# **Final Thomas Creek Restoration Project Year 4 Monitoring Report**

DMS Project ID Number – 96074, DEQ Contract No. 5549

**Subject:** Response to DMS Comments for DRAFT Monitoring Year 4 Report  
Thomas Creek Restoration Project, Wake County  
DMS Project # 96074, DEQ Contract #5549, RFP# 16-005020

**Figure 8. Flow Gauge Graphs**

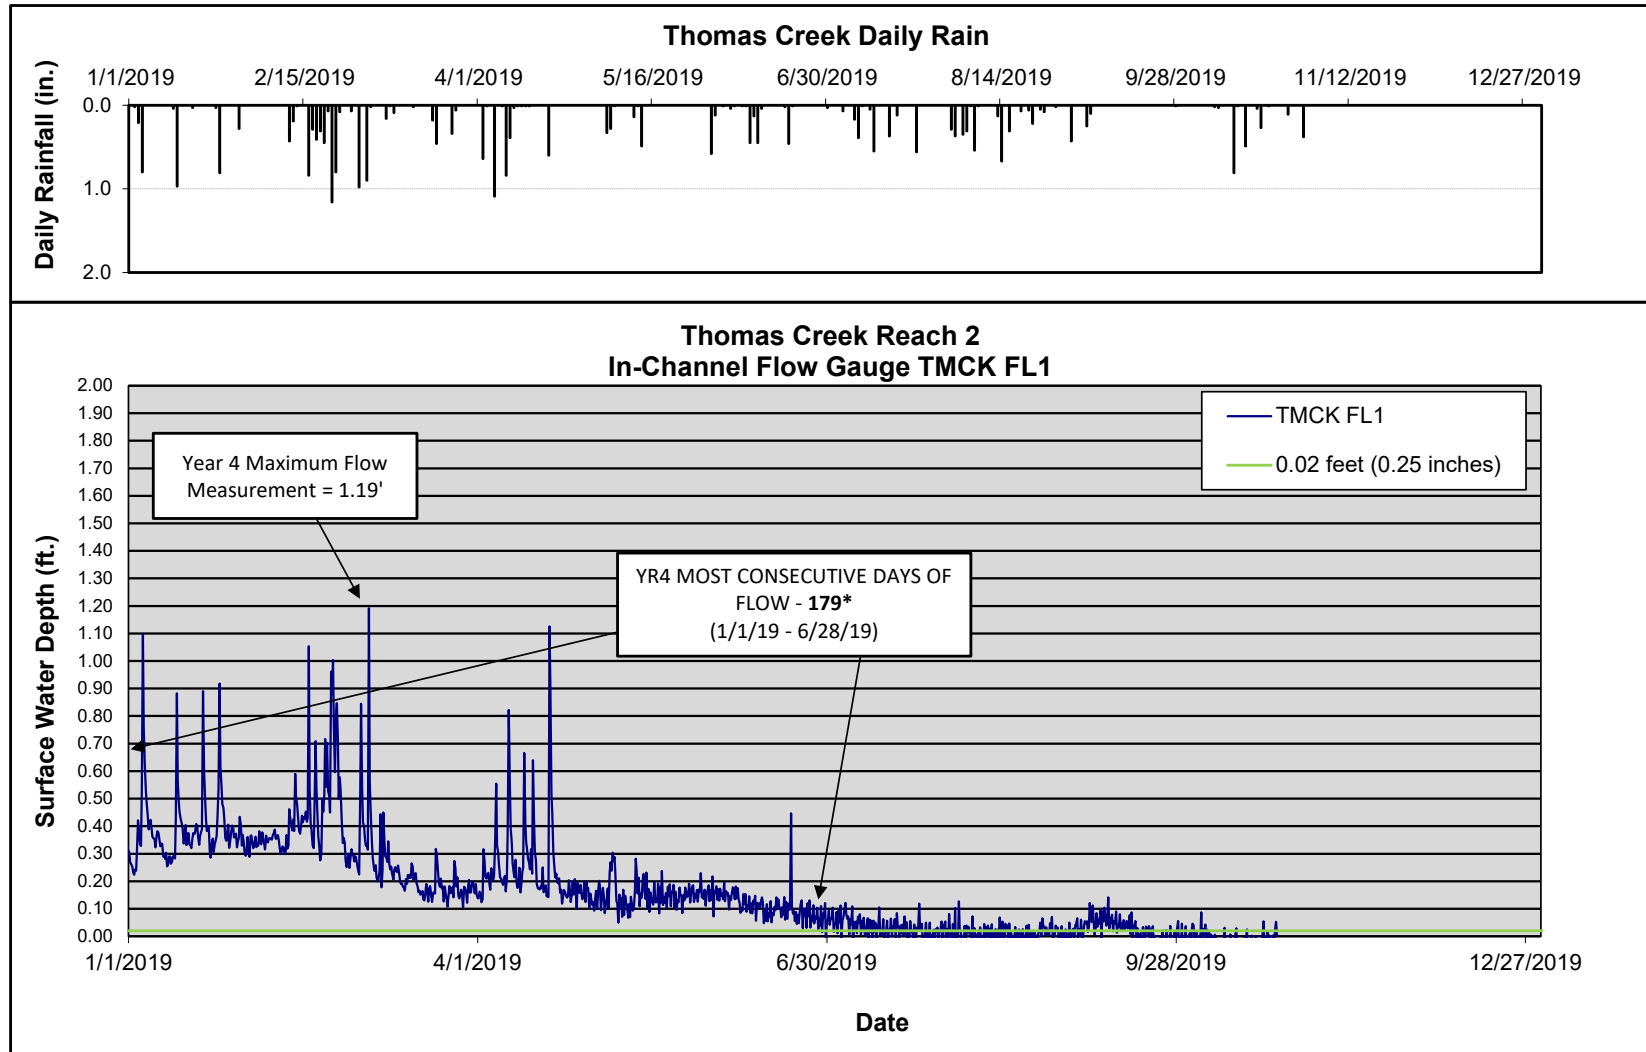
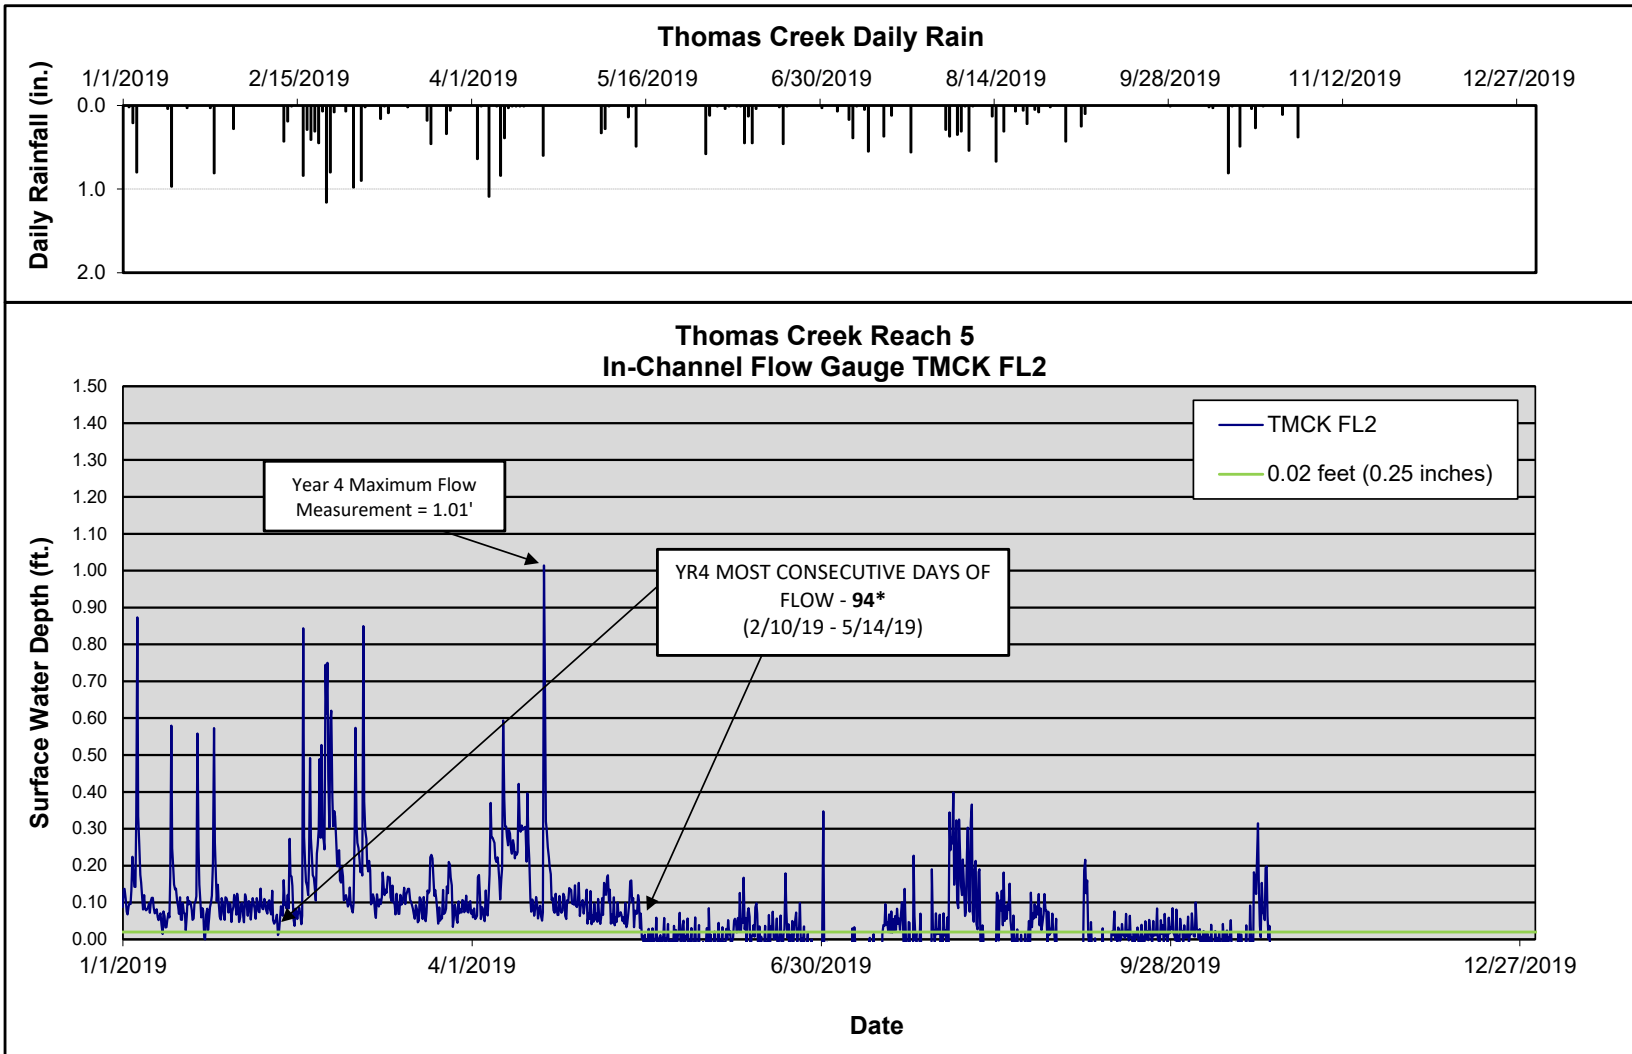
4. Appendix E, Figure 8:

- a. As discussed during the site visit, please update Figure 8 for Flow Gauge TMCK FL2 to call out the point where flow potentially fell below the established surface water depth threshold.

**Response: Baker revised the FL2 flow gauge graph. Upon closer review, the arrow drawn to show when the start of the longest consecutive flow event began was drawn to the incorrect date.**

**However, the consecutive flow length was *calculated* from the correct date and thus the 94-day value shown in both the graph notation and in Table 13 are correct. We apologize for the confusion.**
